ADDENDUM 2

Released: January 31, 2025

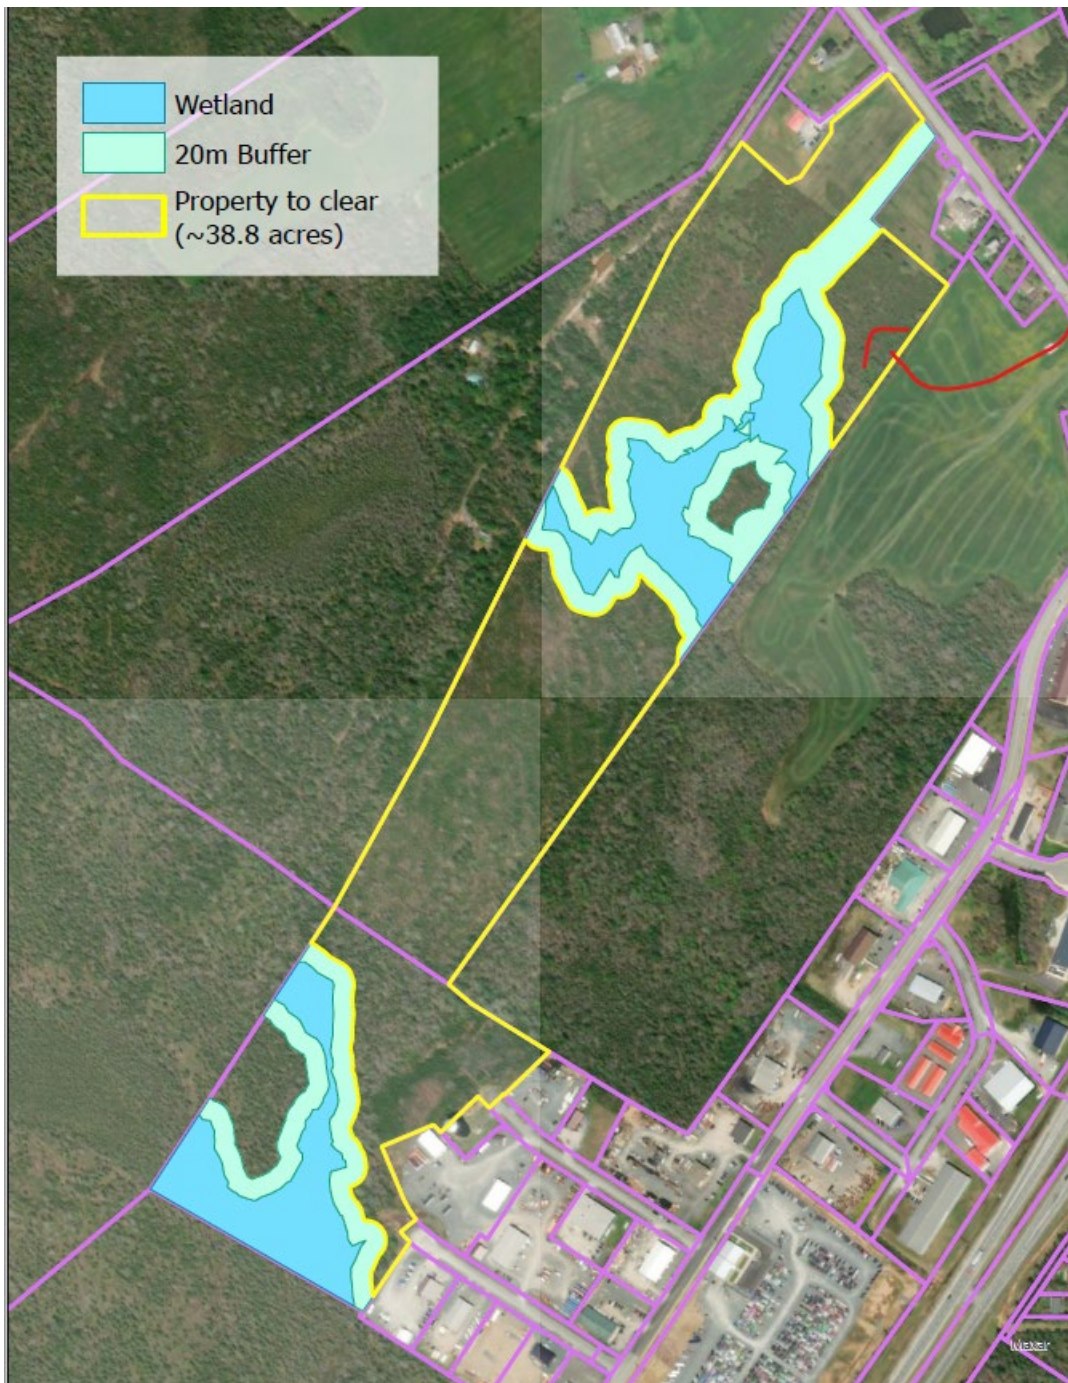
After reviewing the images can you tell me if the lot beside the preschool, is the small space to be cleared accessible through that space by the black arrow?

No. The Municipality has obtained limited permission to unload the machine and track the machine over the neighbouring property to that area, as shown with the red arrow.
